Staff Report for Item 2

Application Number: H15-01-1665

Address: #702 Pearl Street

Description of Work:

Property Appraiser's Photo, c. 1965. Monroe County Public Library.

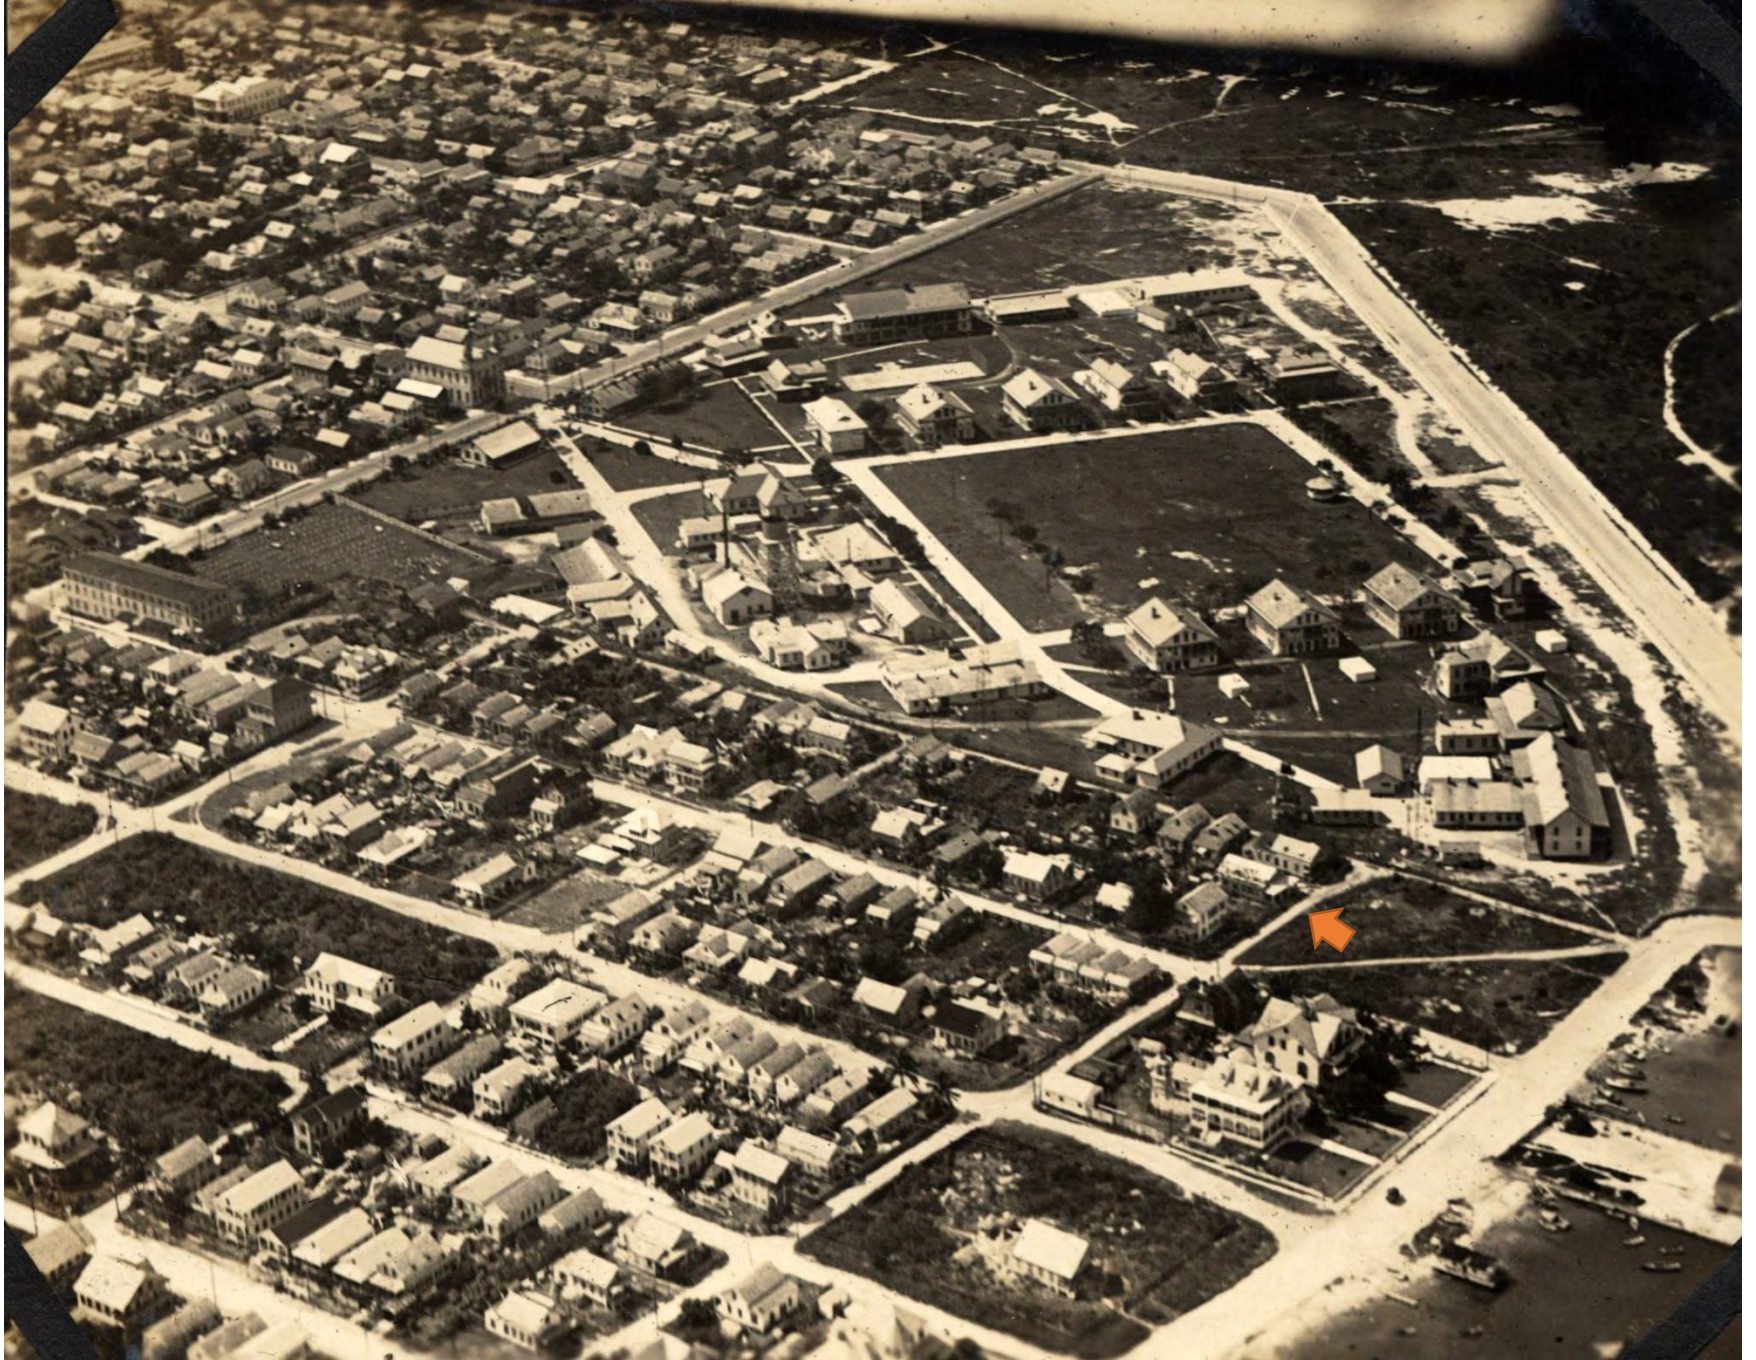
2. **Garage:** The proposed design will minimize the garage, by demolishing parts of the front and sides. The addition of swing garage doors are more appropriate than the existing French doors. Old photographs show that at least during 1972, the structure was most likely used as a carport or garage.

REVISED DESIGN

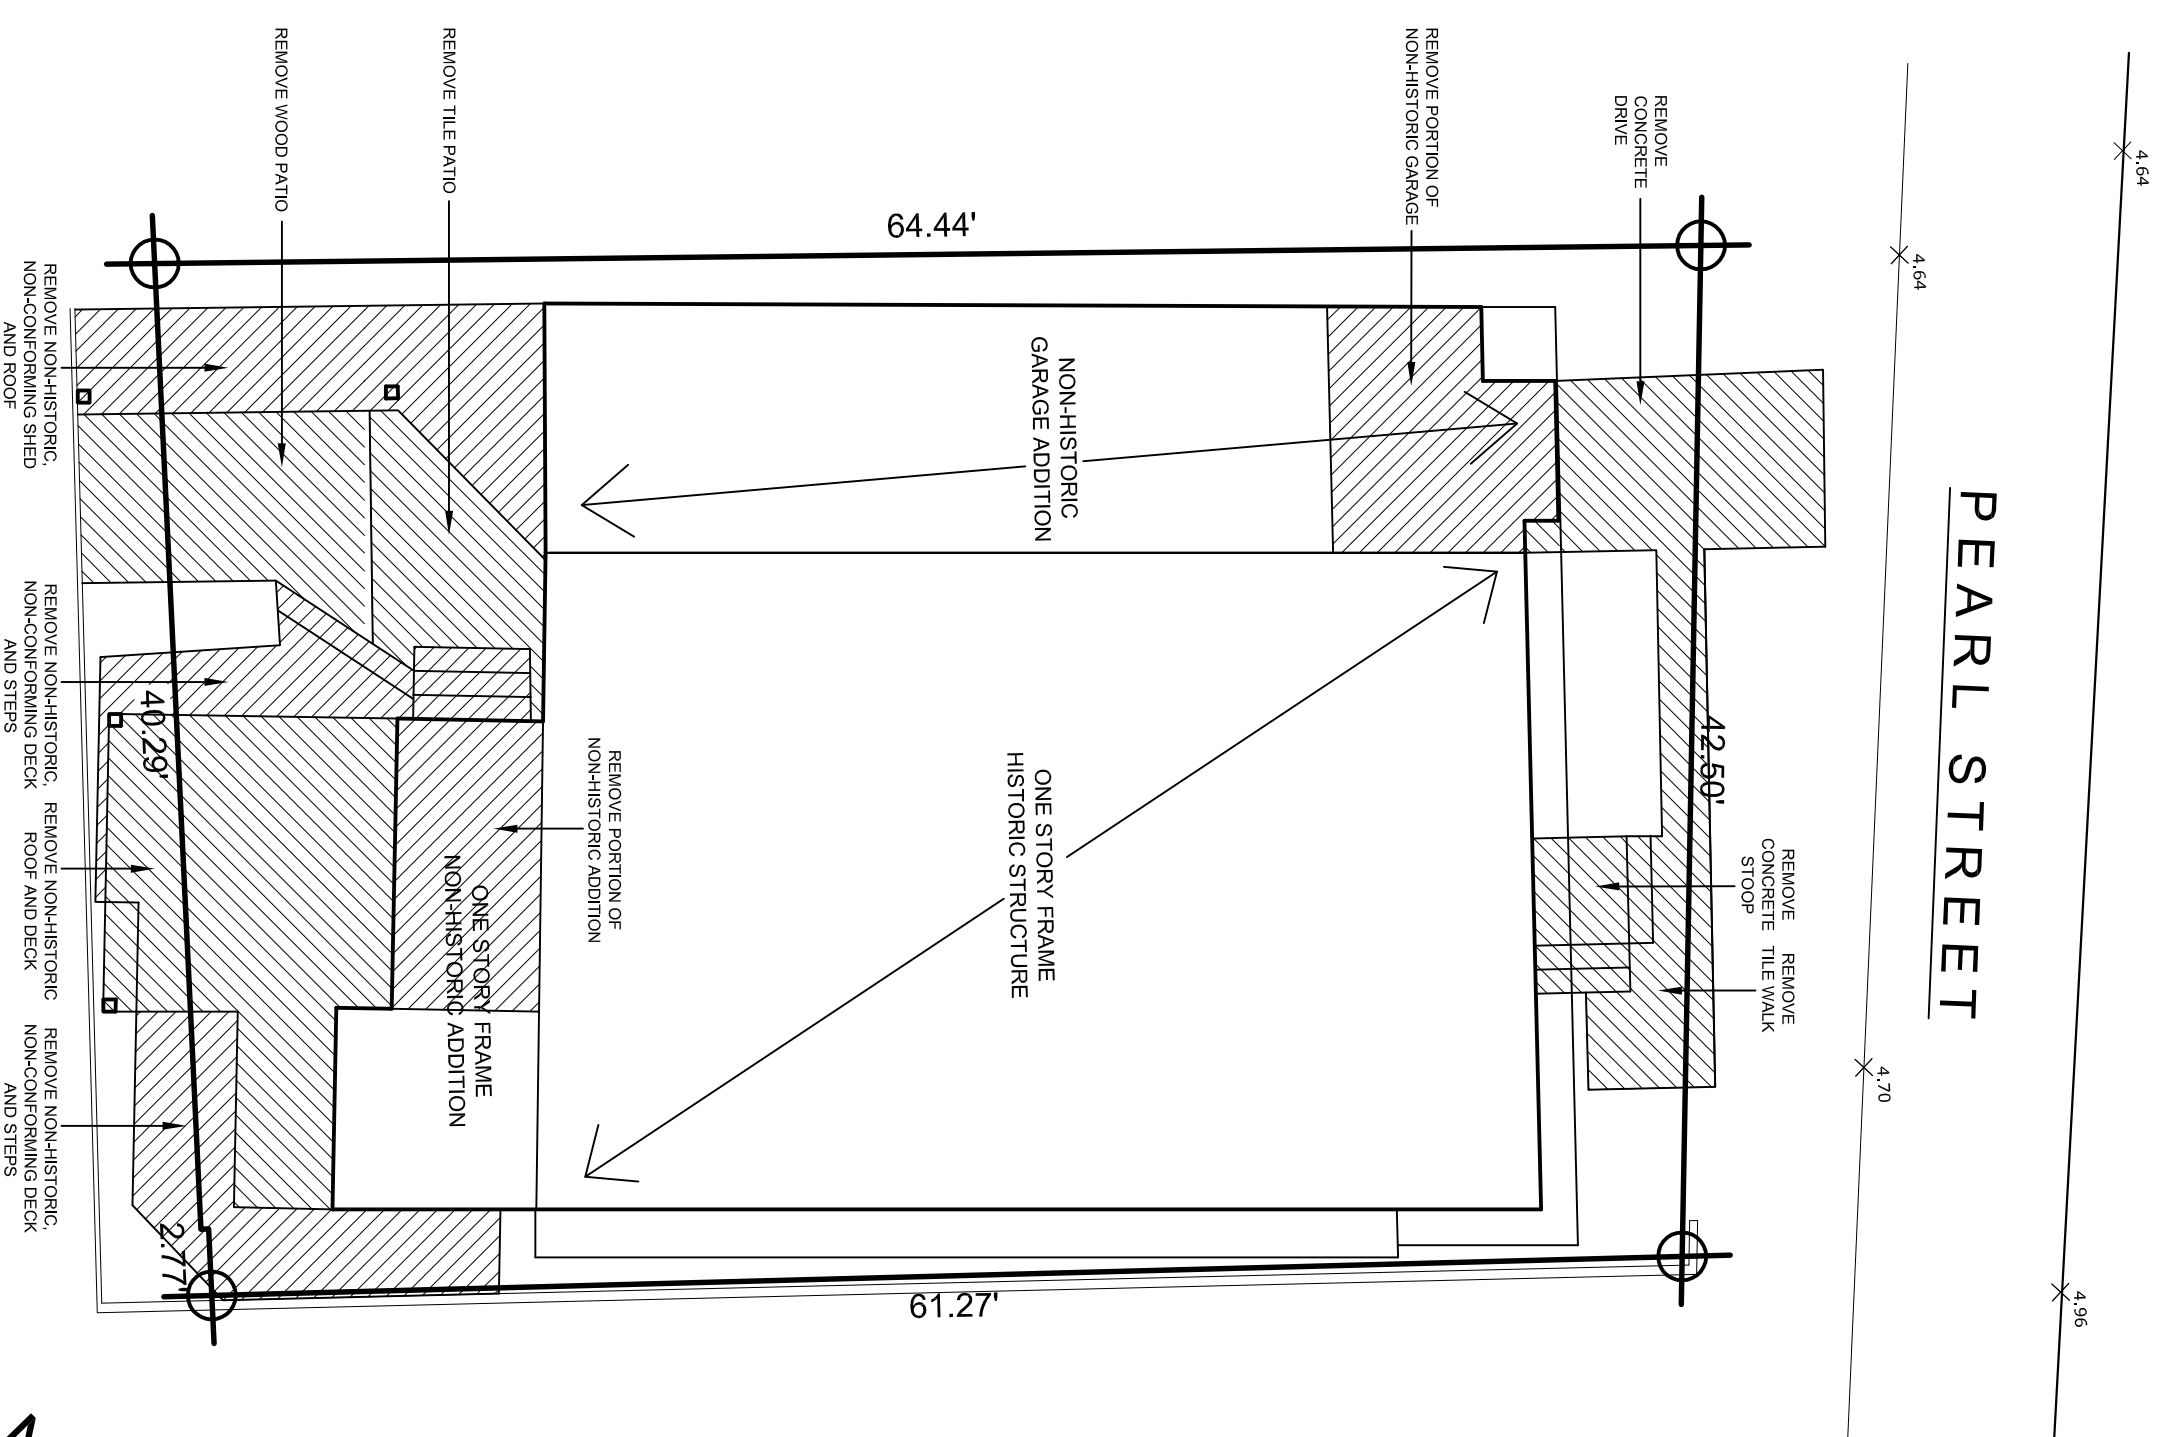
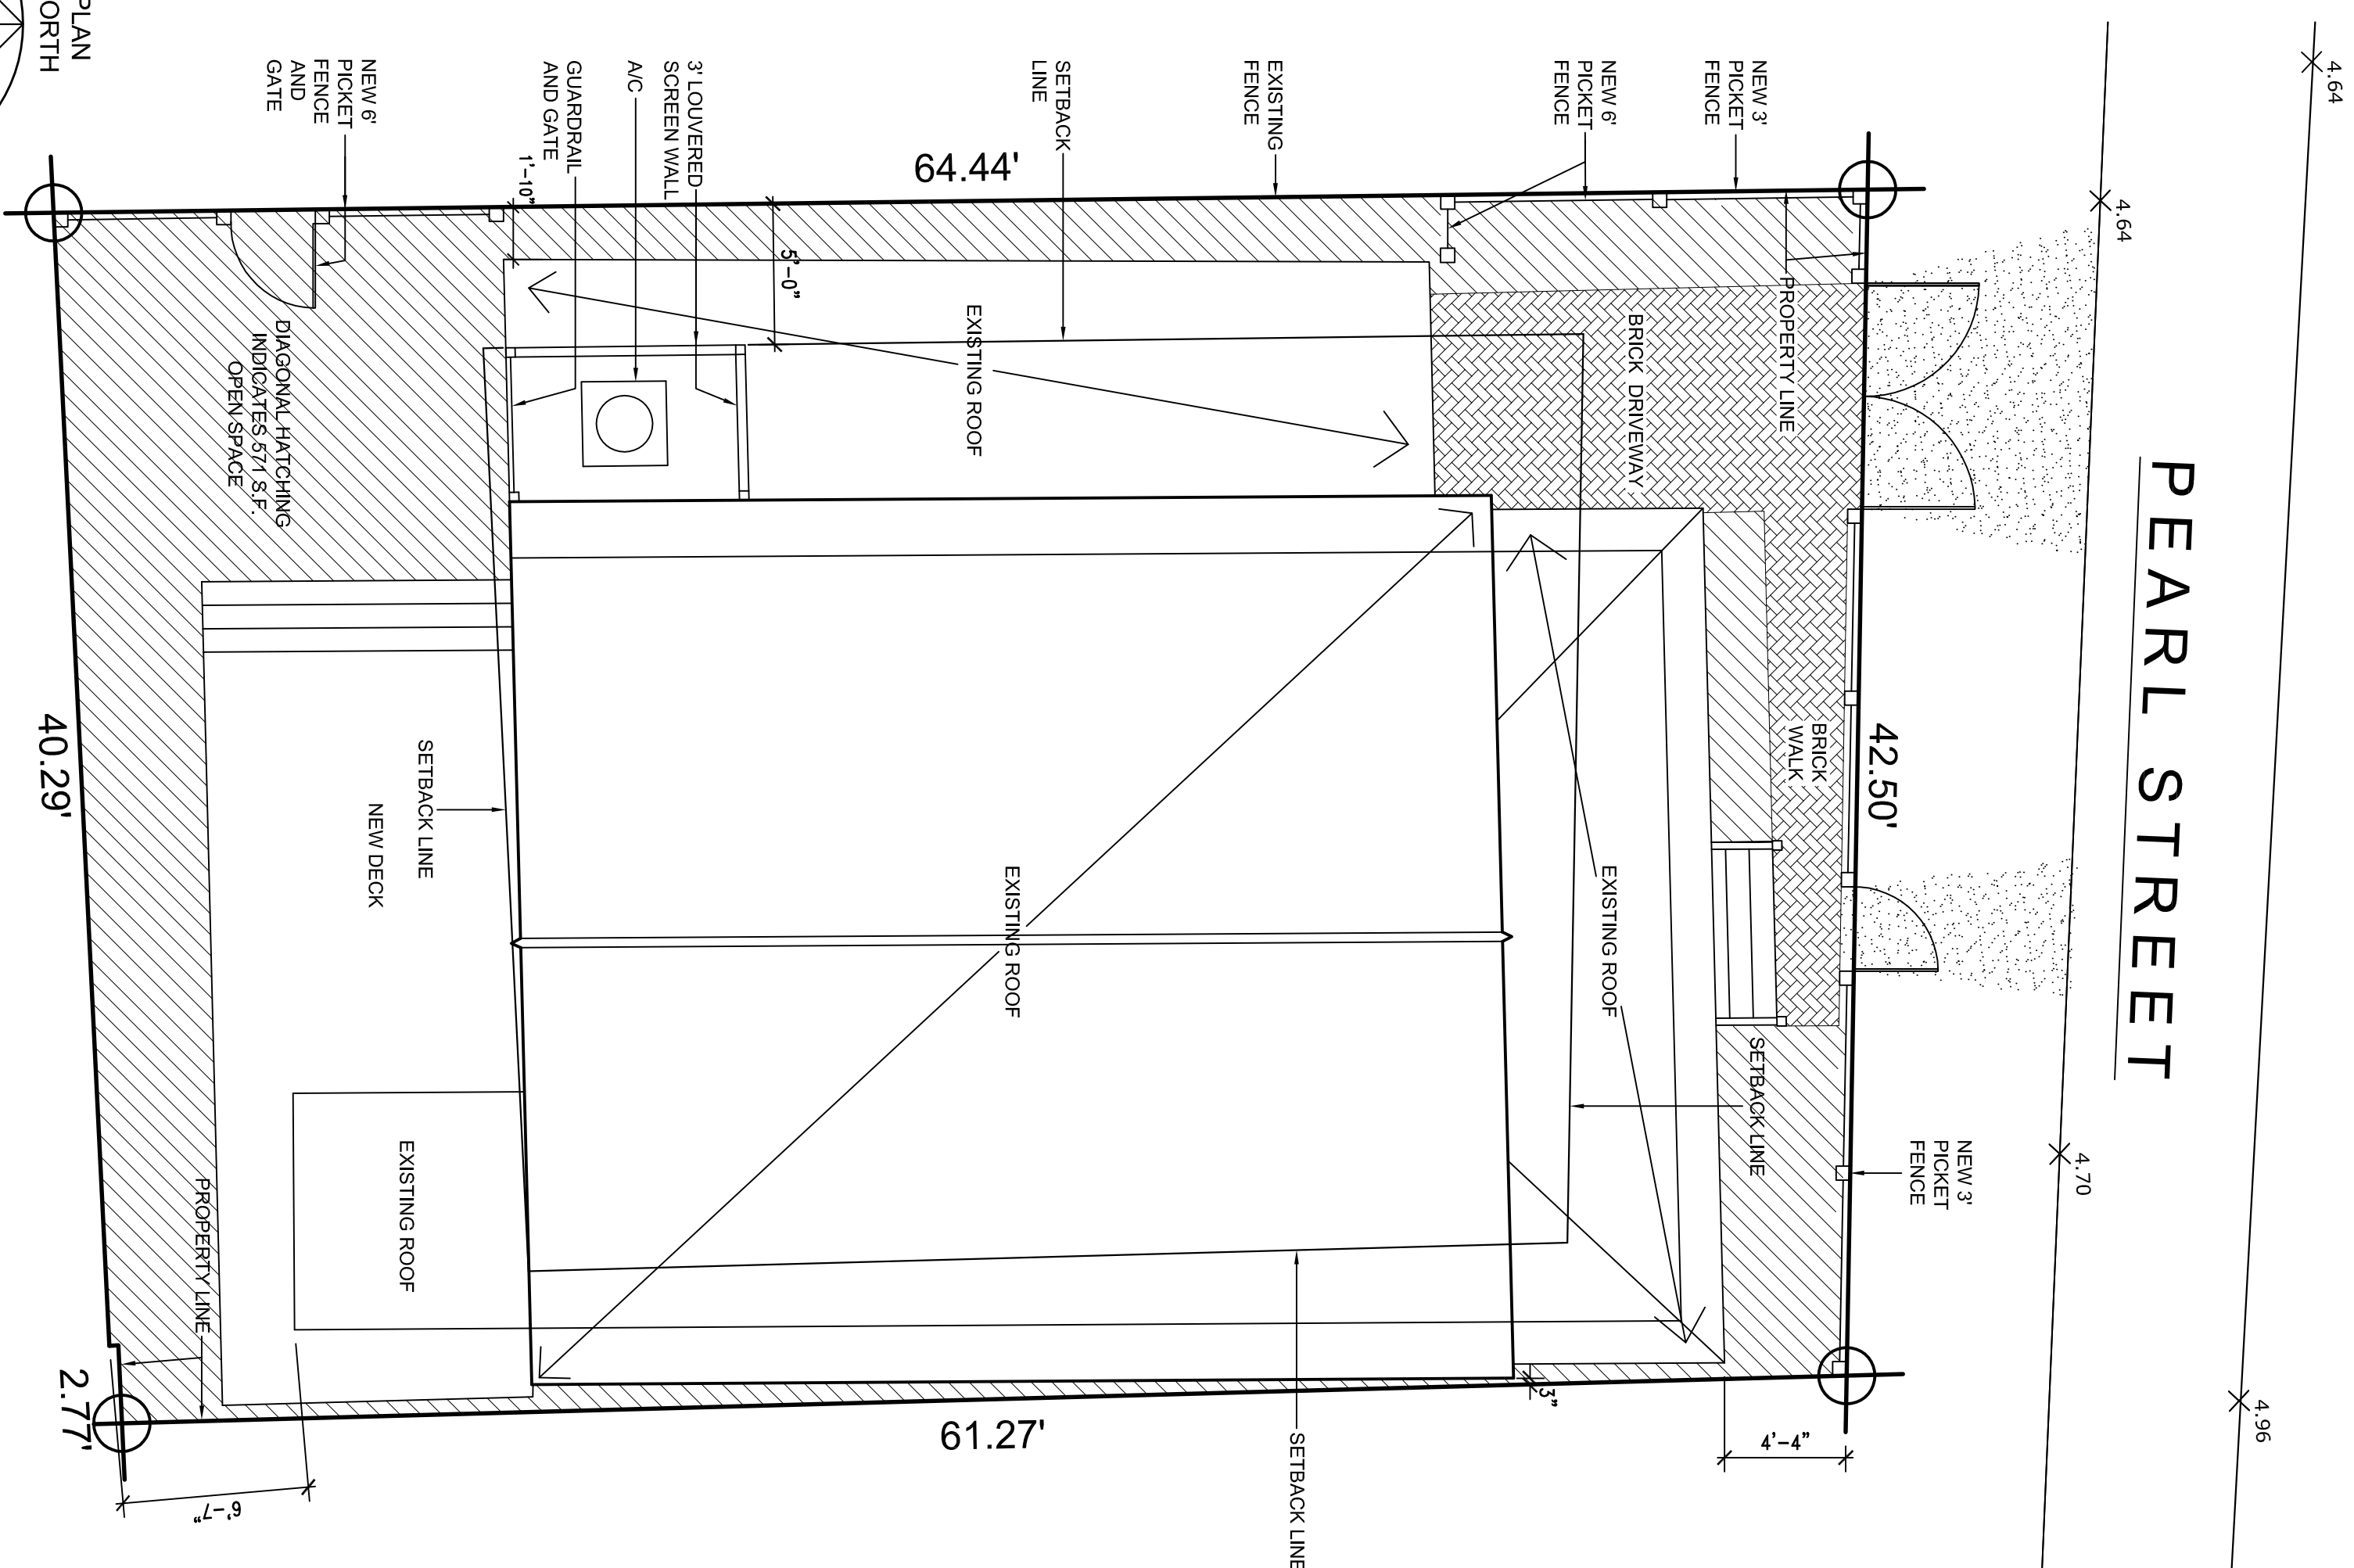
3. **A/C Unit:** The guidelines state that HVAC units should be sited in a location least visible from the public right-of-way whenever possible. It is possible to locate the mechanical equipment directly behind the garage in the rear yard. Mechanical equipment only need 5 feet setback, and there are many reasonable places to locate the equipment in the backyard.

When speaking with Kelly recently about your issue concerning the condenser location, I told her that I would speak with the owner about the matter. I have spoken with them and we thoroughly discussed all the options we were able to conceive of regarding alternate locations of this equipment to the current location on the rear of the garage roof as shown in my drawings.

Because the lot is substandard, the building drastically crowds the rear property line and leaves very little area for outdoor activities and foliage. That and the condition by Planning that such equipment cannot be any closer to the side and rear property lines than 5'-0" leaves no real desirable alternative. I would ask you to look closely at the drawings to verify these conditions.

Furthermore, I am convinced that the proposed location on the garage roof, well outside the side yard building setback line and at the extreme rear of garage would render the equipment not viewable from the street. A visit to the site would verify this. The height at the lowest end of the roof is 9'-6" and it slopes to higher at the house.

As mentioned in the staff report given the 5 foot setback requirement for AC units it is clear that an alternative location on the ground could be considered. If the re-design moves the railings out of the setback and the proposed second story is not in the required side yard setback, planning staff has no issues. Please coordinate with HARC staff moving forward.
